Intel® 450NX PCIset Specification Update

Release Date: April 1999

Order Number: 243848-009

Figure 2. Timing Window Where Strobe Falling Edge Must Be Avoided

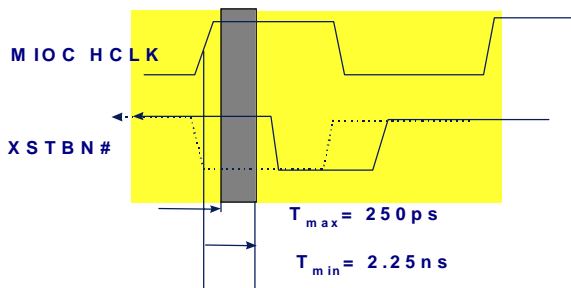
PROBLEM: The MIOC component erroneously checks parity on the expander (F16) bus during the turn-around cycle immediately following a PXB-driven packet and the start of an MIOC-driven packet. If a very specific timing relationship exists between the MIOC's clock and the arriving XSTRB# signals exists (XSTRBN# strobe falling-edge arrives at the MIOC right coincident with the start of the data bus being driven by the MIOC), data and parity sampled by the strobes may be inconsistent due to bit-skew and/or metastability. An F16 Bus Parity Error may be erroneously flagged.

IMPLICATIONS: An Expander (F16) Bus error, when detected, will cause an F16 Bus Parity Error to be flagged in the MIOC's ERRSTS register and displayed on the ERR#[1:0] monitor pins. While no data corruption would result, the erroneous parity check and resulting failure may result in a BINIT# assertion by the chipset when BINIT# assertion is enabled.

WORKAROUND: The failure band is narrow enough that slightly varying XSTBN# falling-edge arrival with respect to MIOC's data-output timing can prevent the failure from occurring. Delaying XnCLK from the MIOC to the PXB can vary this timing and can be accomplished by adding extra loading or trace-routing to the XnCLK signal routing (if adjusting the entire F16-bus routing is not feasible due to existing board layout). To assist in designing board layout for avoidance of this problem, consider calculating the sum of the following system timing parameters and comparing against the limits of the failure band or timing "window."

$$HCLK / XpClkFB \text{ Skew} + XpClkFB / XpClk \text{ Skew} + T66 + XpXSTBN\# \text{ Flight time} \leq (T_{PERIOD} + 250 \text{ ps}), \text{ or } > (T_{PERIOD} + 2.25 \text{ ns})$$

Implementing this workaround may require deviating from the clock-skew specification. The skew between XpClkFB at the MIOC and XpCLK at the PXB may need to increase to account for a delay to the XpCLK line. Note that due to min/ max parameter variances, it may not be possible to design a workaround which can guarantee avoidance of the failing timing scenario, at least not without violating other timings. If this is the case, calculating the above timing and comparing min/ typ/ max values may still provide some assistance in designing a system workaround which could minimize exposure to this problem.
